**CDCP 2021 Compliance Table
DEVELOPMENT IN BUSINESS SITE SPECIFIC**

Relevant Control		Compliance with Requirements	Consistency Objectives
Part A – General Controls			
Part F2 – Business Site Specific			
Part F2-8 – Merrylands Station and McFarlane Street Precinct

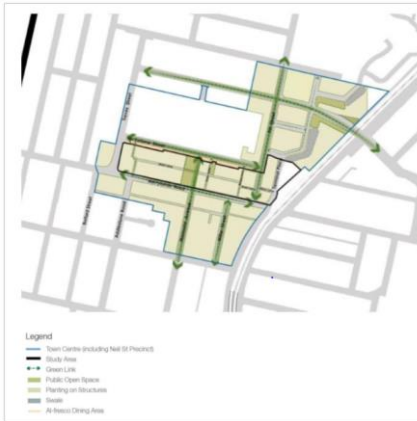
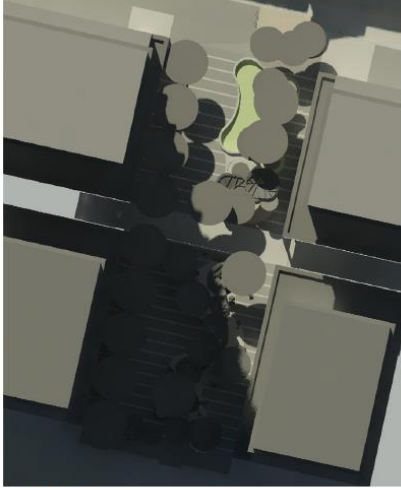
<p>Figure 2: Movement principles</p>		
2.2.2 Open Space	<p>Establish a secondary green link through north-south laneways, between Merrylands Road and MacFarlane Street. Refer Figure 3.</p>  <p>Figure 3: Open space principles</p>	<p>The pedestrian link coloured in green as shown in Figure 2 is proposed to be shifted towards the middle part of the Civic Square.</p>	<p>No – refer to detailed assessment in the report.</p>
